DRAINAGE LETTER REPORT

STRUTHERS RANCH POLARIS 847 STRUTHERS RANCH ROAD LOTS 1-2, STRUTHERS RANCH SUBDIVISION FILING NO. 4

JPS Project No. 032203

PCD Filing No.:
PPR2248

DETENTION BASIN OUTLET STRUCTURE DESIGN

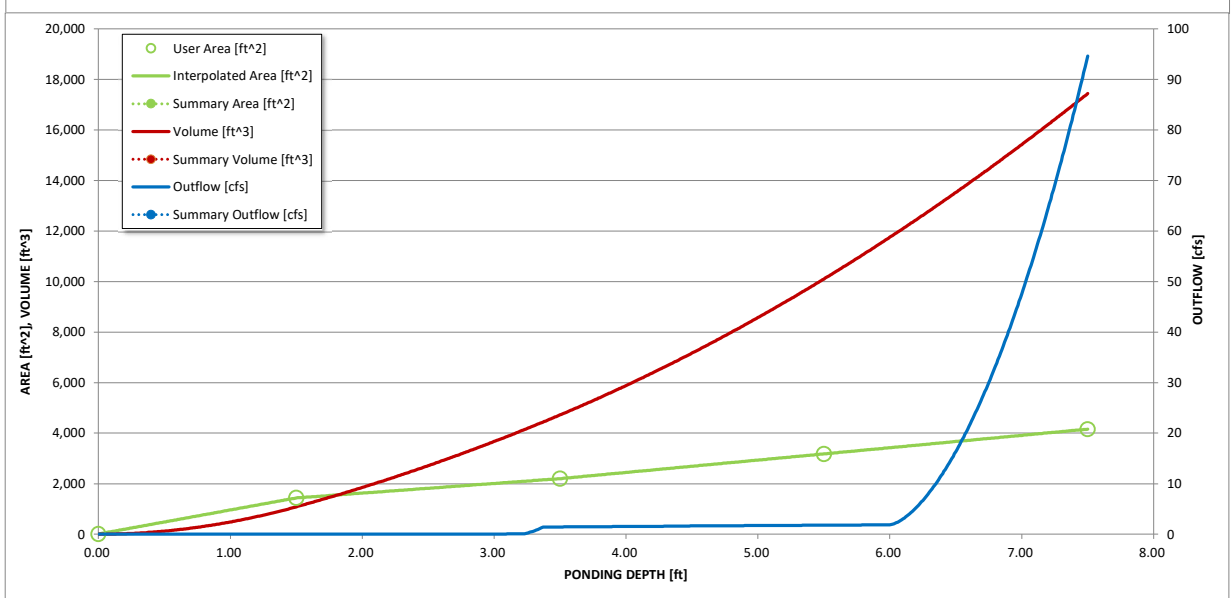
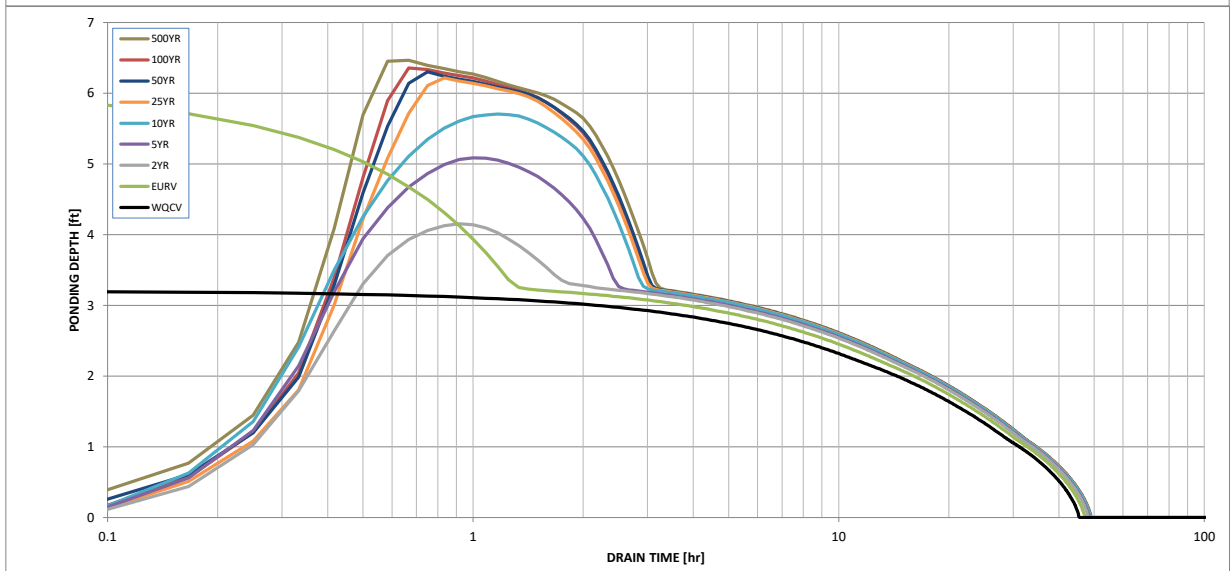
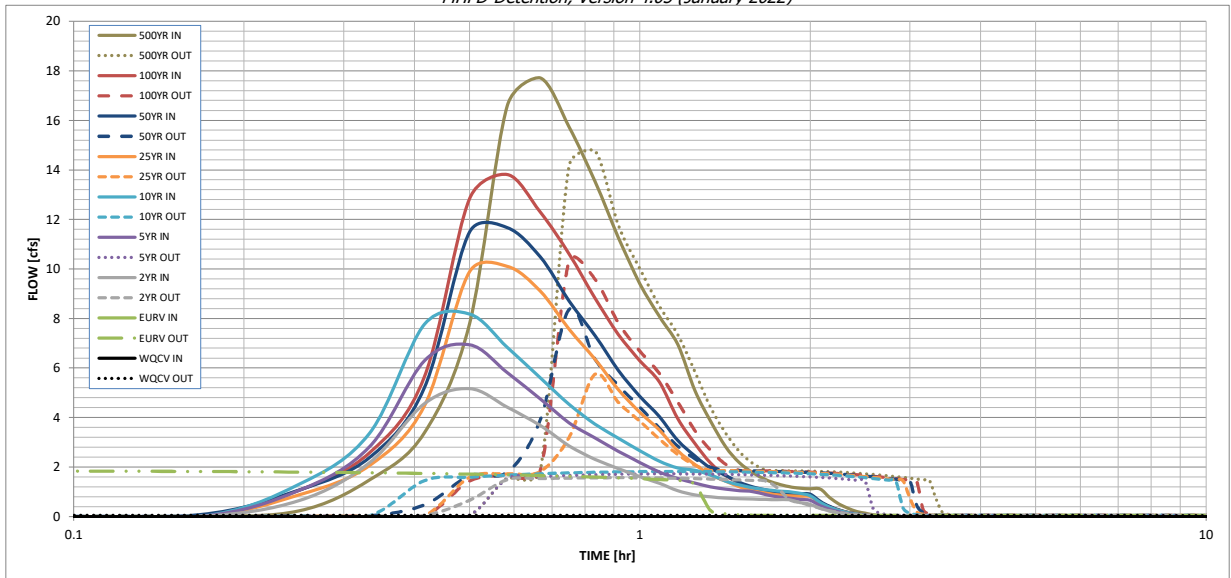
WQCV should be controlled by the Outlet Plate

Check why these all aren't overflow weir or spillway

Designer: JPS
Company: JPS
Date: August 10, 2022
Project: Struthers Ranch Polaris
Location: Detention Basin A

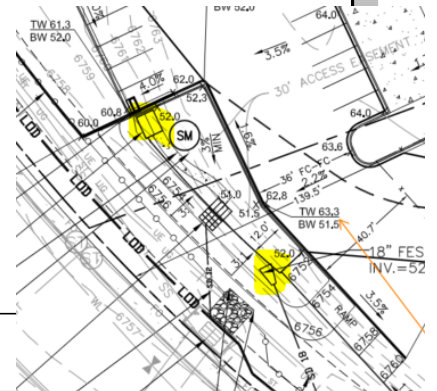
In sizing the forebay revise the area and impervious specific to what's tributary to the northern forebay.

HORZ. SCALE:	1"=30'	DRAWN:	PV
VERT. SCALE:	N/A	DESIGNED:	JPS
SURVEYED:	COMPASS	CHECKED:	JPS
CREATED:	05/27/20	LAST MODIFIED:	08/10/22
PROJECT NO.:	032203	MODIFIED BY:	PV
SHEET:	D1.1

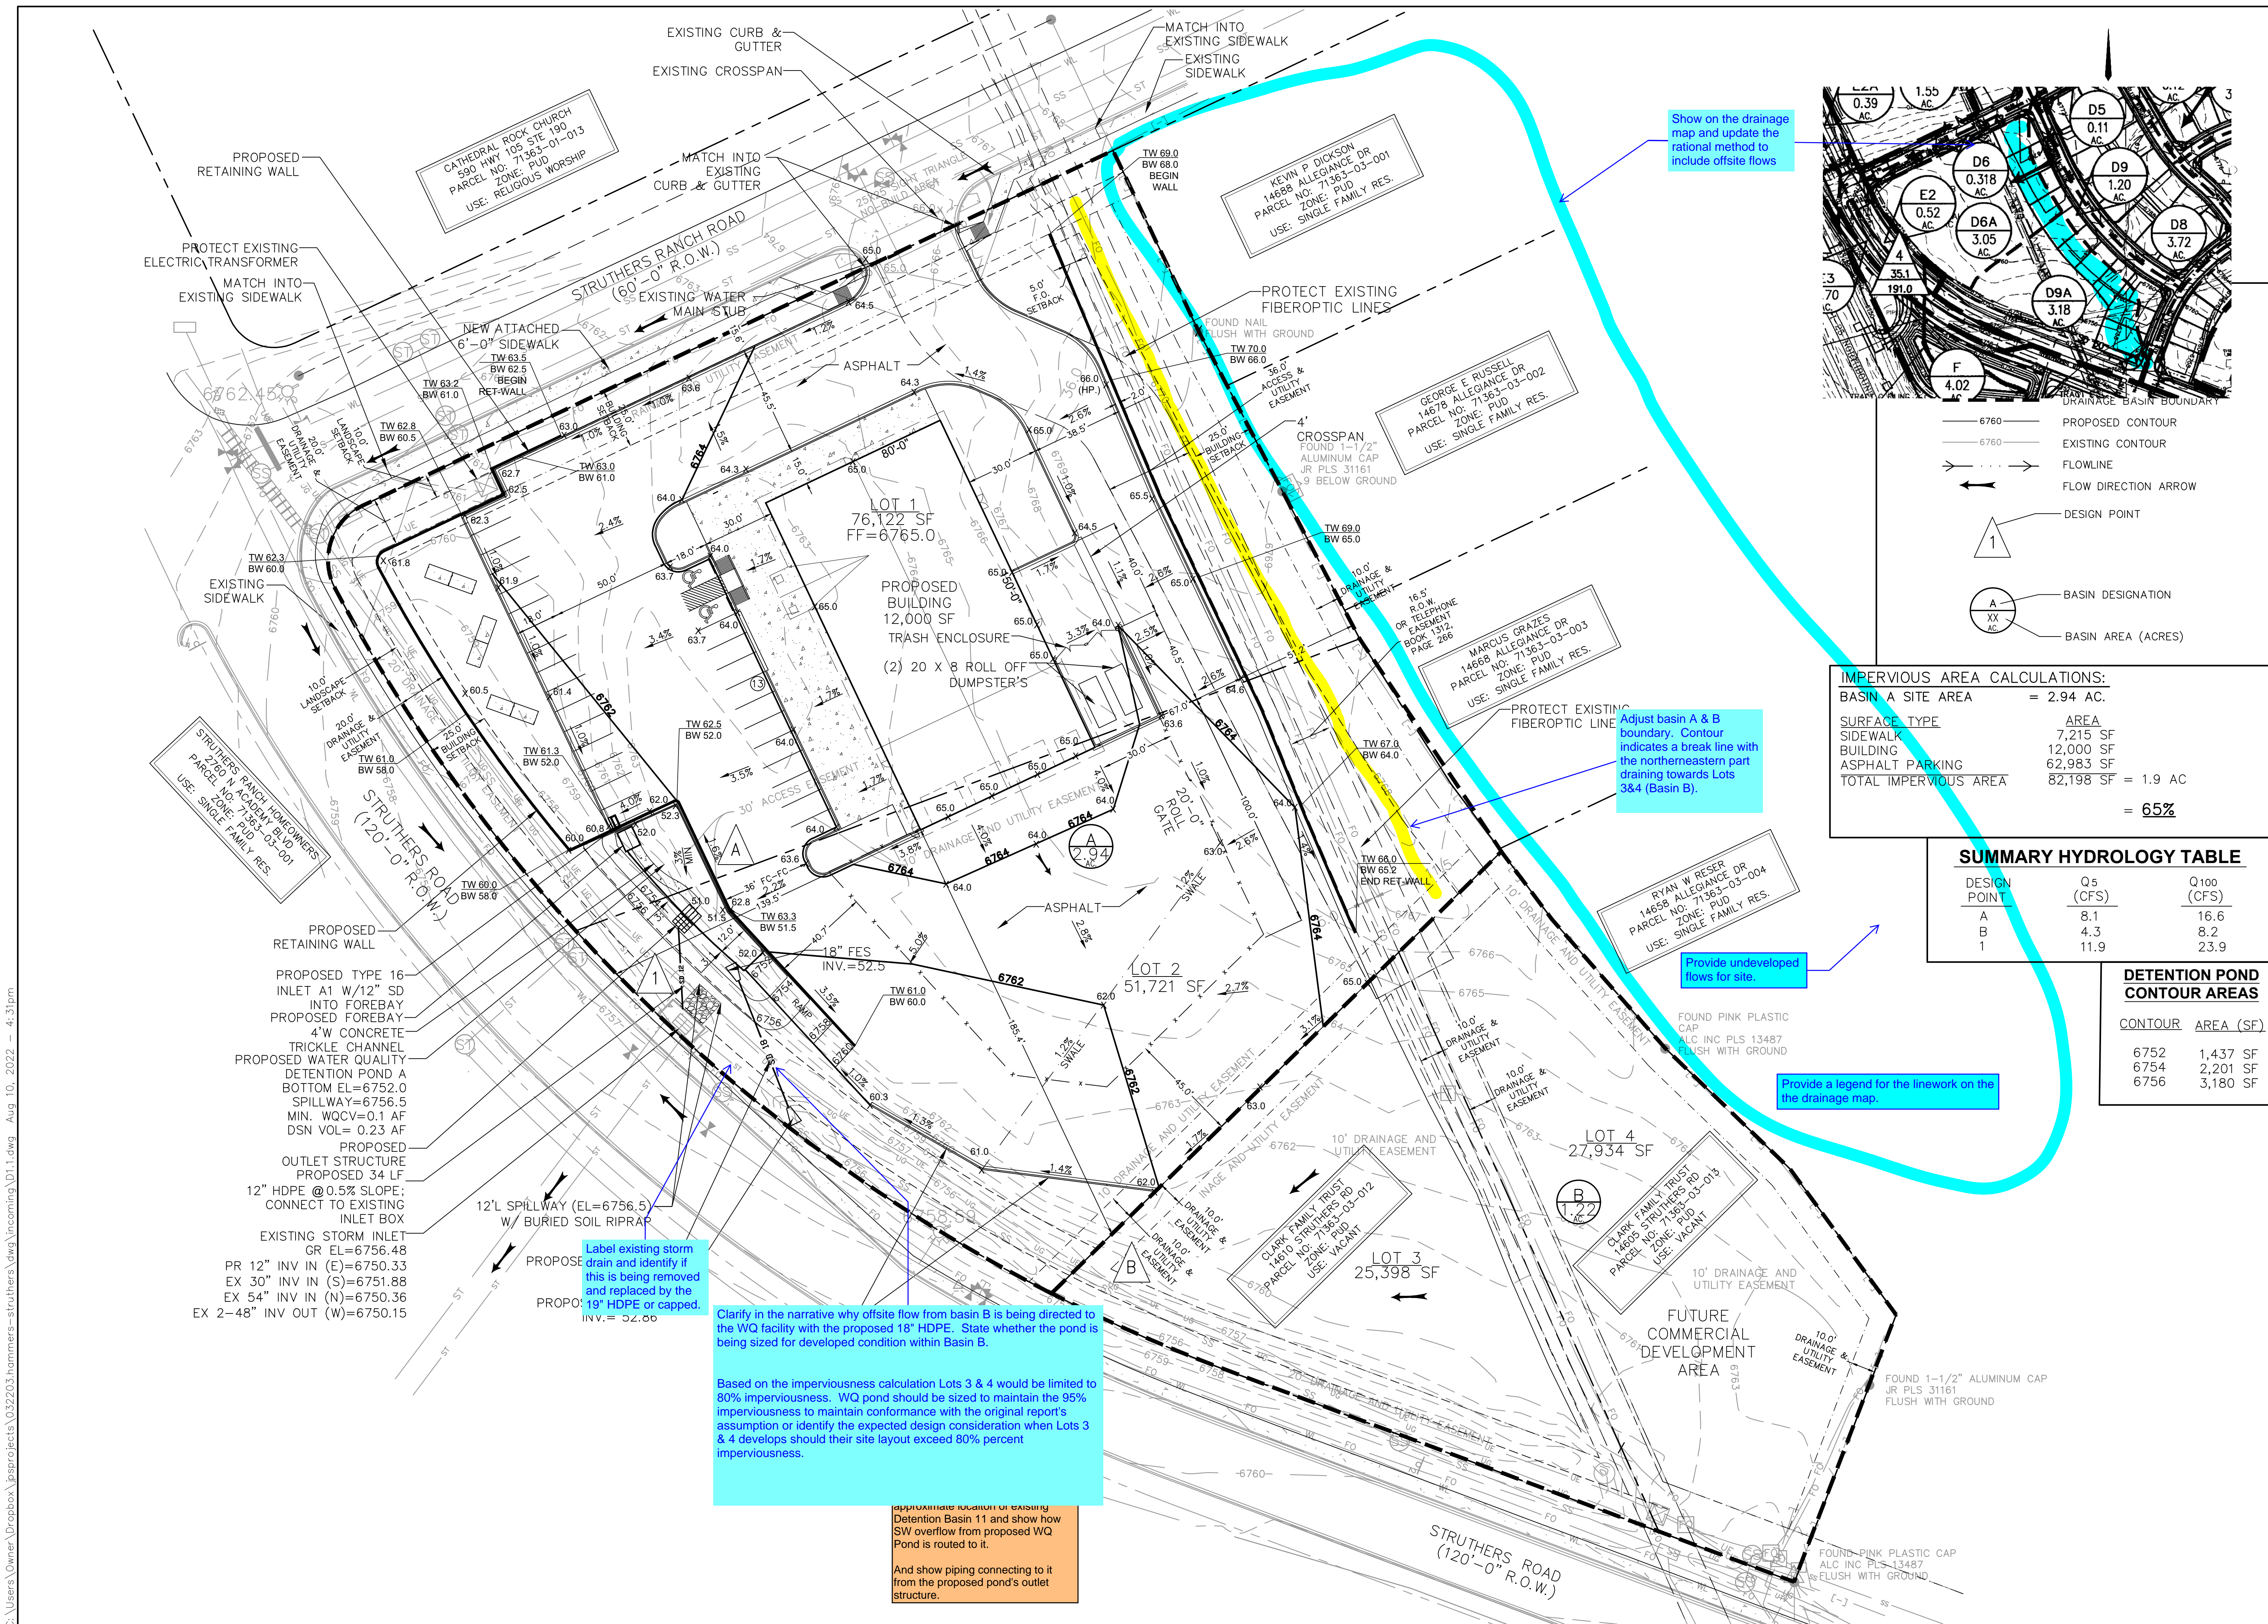
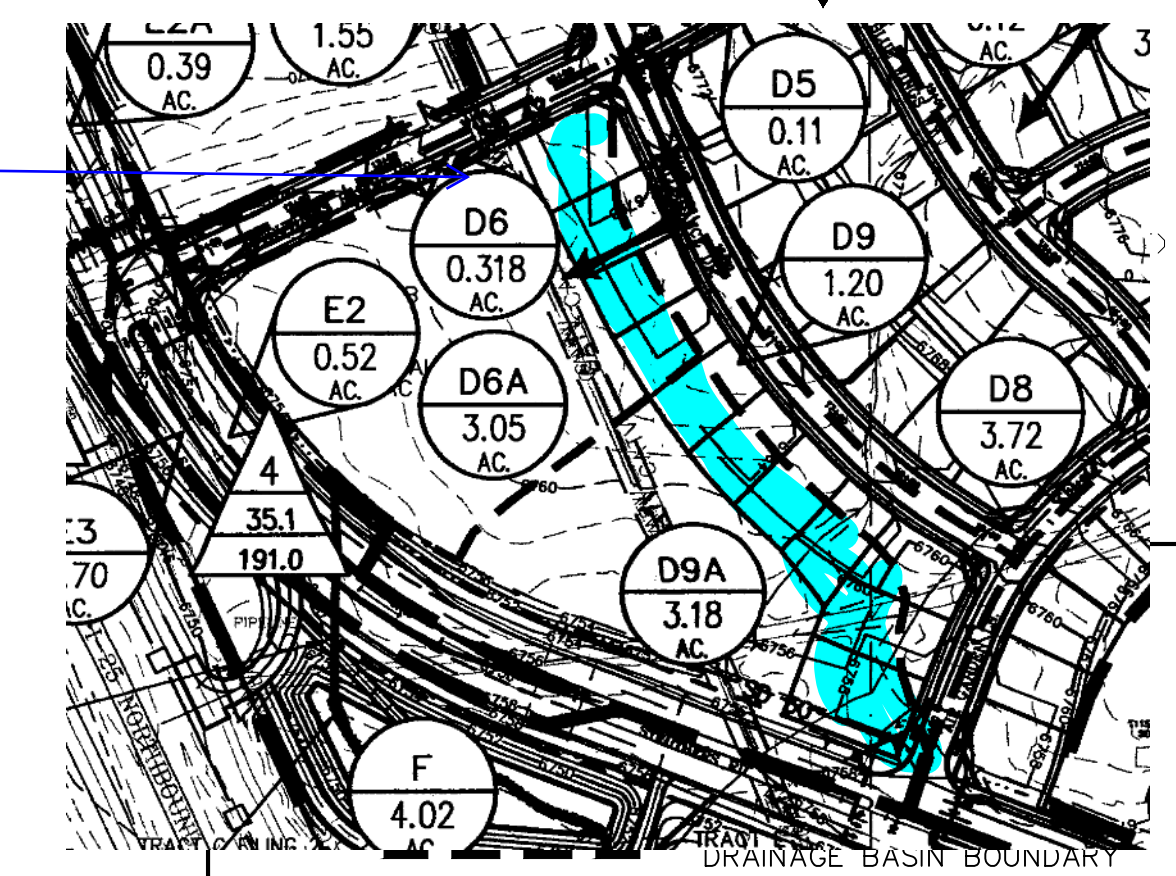
Show on the drainage map and update the rational method to include offsite flows

Adjust basin A & B boundary. Contour indicates a break line with the northeastern part draining towards Lots 3&4 (Basin B).

Provide undeveloped flows for site.

Provide a legend for the linework on the drainage map.

Label existing storm drain and identify if this is being removed and replaced by the 19" HDPE or capped.

Clarify in the narrative why offsite flow from basin B is being directed to the WQ facility with the proposed 18" HDPE. State whether the pond is being sized for developed condition within Basin B.

approximate location of existing Detention Basin 11 and show how SW overflow from proposed WQ Pond is routed to it.
And show piping connecting to it from the proposed pond's outlet structure.

At least label (if you dont have topo) approximate location of existing Detention Basin 11 and show how SW overflow from proposed WQ Pond is routed to it.

And show piping connecting to it from the proposed pond's outlet structure.
